Technical Note - Highway Issues

Site: 19 Ogmore Close, Tilehurst, Reading
Prepared by: Chris Saunders
Approved by: John Russell
Date: 12th June 2024

Figure 2.1 – Collision Plot Output.

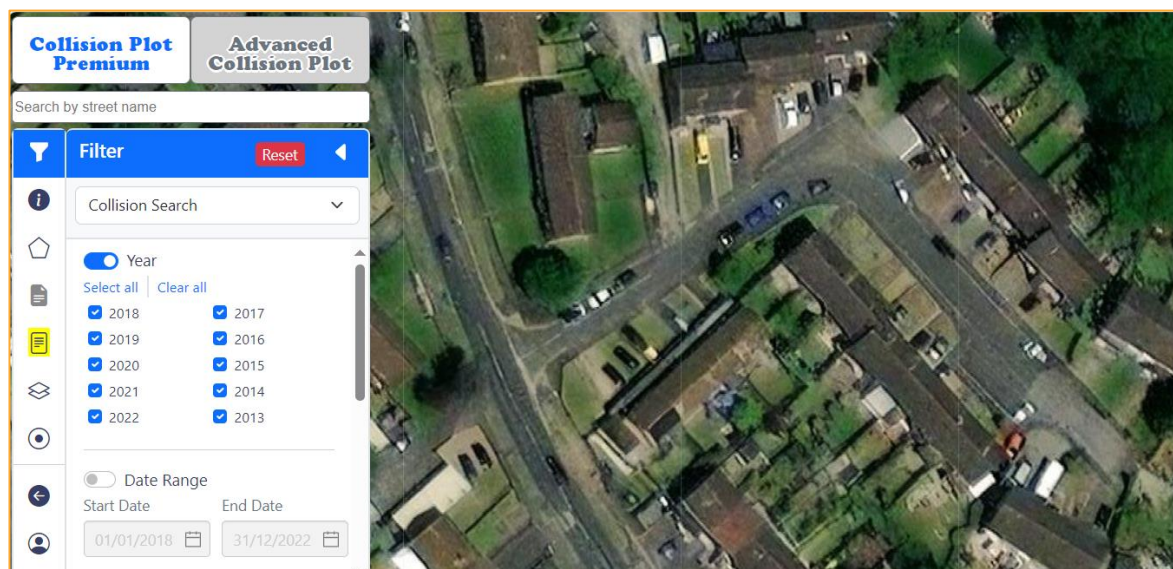
- 2.1 The Highway Officer has accepted that the parking provision proposed is acceptable, but has stated that as two dwellings are to be served from a single drive, a turning area is required. Ogmore Close is a residential cul-de-sac and shared driveways are a common occurrence on such roads. It is noteworthy that there are already shared driveways along Ogmore Close and not a single property is provided with a turning area, with all parking spaces requiring a reversing manoeuvre either on to or from the driveway.
- 2.2 To ascertain the implications for road safety, of the fact, that no driveways are provided with a turning area, a review of the Collision Plot dataset has been undertaken. Accident data along Ogmore Close for the last ten year period of available data has been analysed, with the results provided within Figure 2.1.

- 2.3 Figure 2.1 details that no recorded accidents have occurred along Ogmore Close within the last ten year period, showing that the lack of turning areas on driveways along the close is not detrimental to road safety.
